RESPONSES TO CEC DATA REQUESTS (#79-100)

APPLICATION FOR CERTIFICATION (07-AFC-8)
Carrizo Energy Solar Farm
Carrizo Energy, LLC

Carrizo Energy Solar Farm (07-AFC-8) Responses to CEC Data Requests #79-100

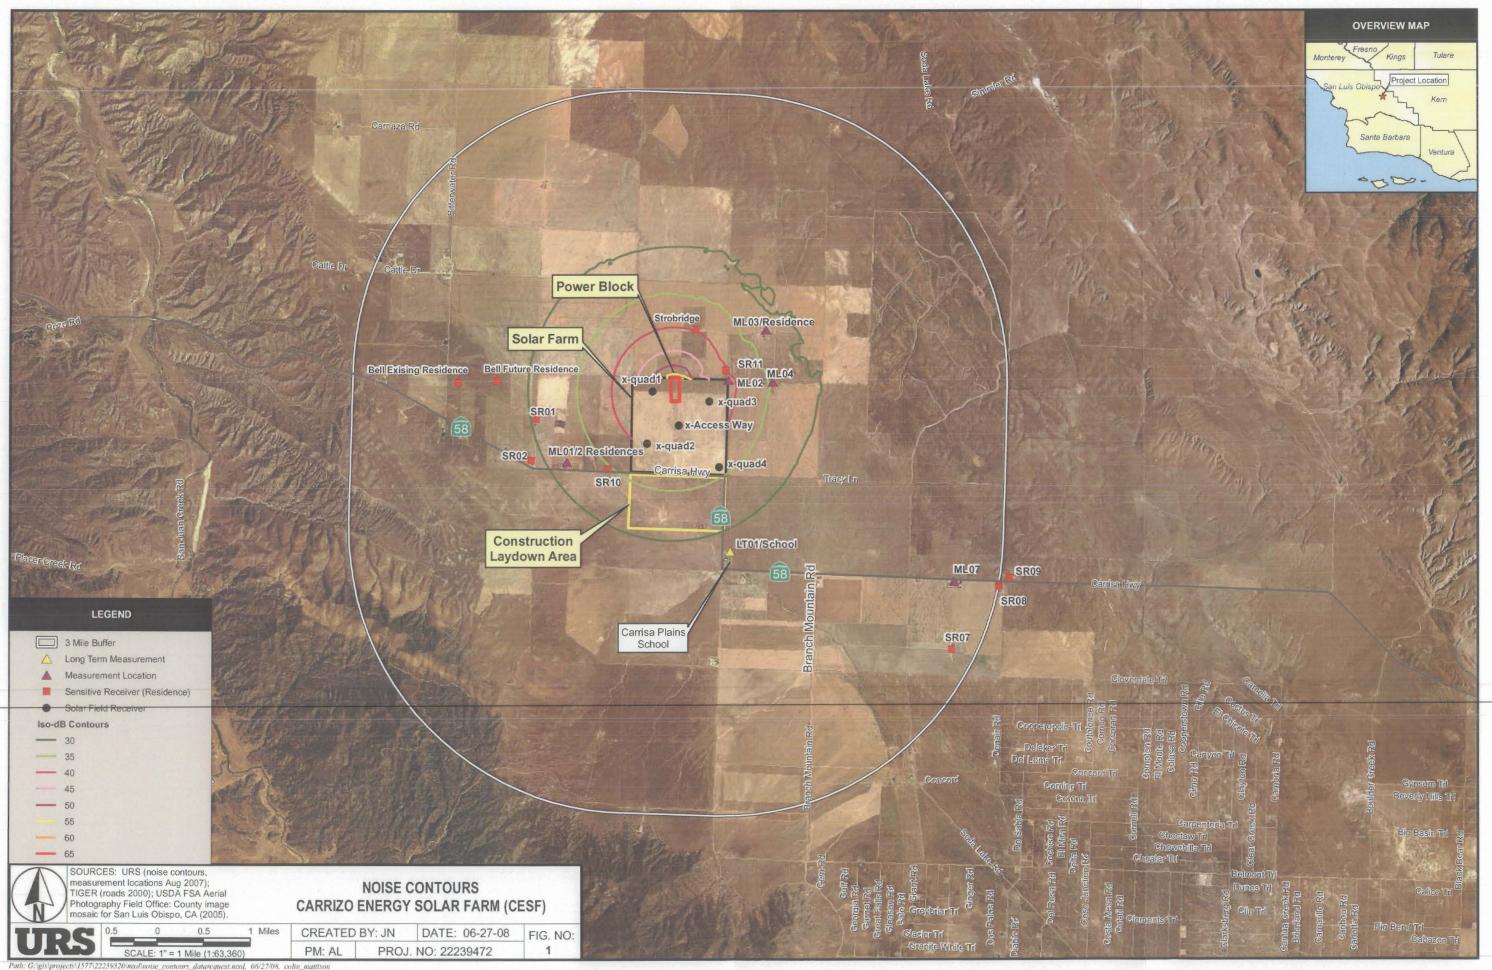
Please identify all new residences built since June 2007 and all planned residential developments that the applicant is aware of, within the 3-mile radius of the center of the project site, on a noise contour map similar to AFC Figure 5.12-1.

Based on communications with landowners in the vicinity of the Project, three planned residential developments were identified within the 3-mile radius of the Project site: APN 072-051-026 (Strobridge), APN 072-301-001 (Bell Future Residence), and APN 072-311-004 (Bell Existing Residence) (see Figure 1).

Predicted Aggregate Construction dBA per Planned Construction Month

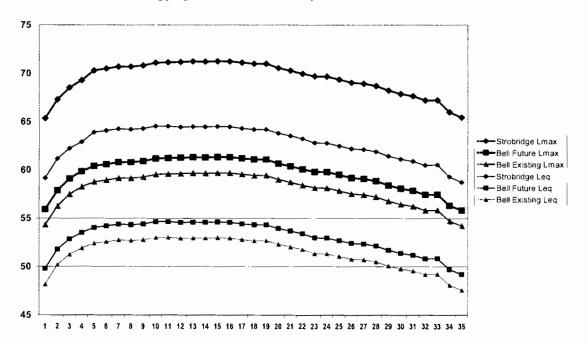
Please provide the estimated project noise levels at these locations, during both construction and operation.

The chart associated with the table depicts how the L_{eq} and L_{max} aggregate construction noise levels are expected to change from month to month, based on the planned construction schedule.

Furthermore, the highest expected L_{max} levels from construction as received by the Strobridge location are within 1-2 dBA of the SLO County Noise Element limit (70 dB from Table 3-2 of the SLO Noise Element) for L_{max} from stationary (i.e., non-transportation) noise sources at a receiving property line. Additionally, at both of the Bell residence locations (existing and future), the anticipated L_{eq} is not expected to range more than 5 dBA greater than the 50 dBA limit for stationary noise sources.
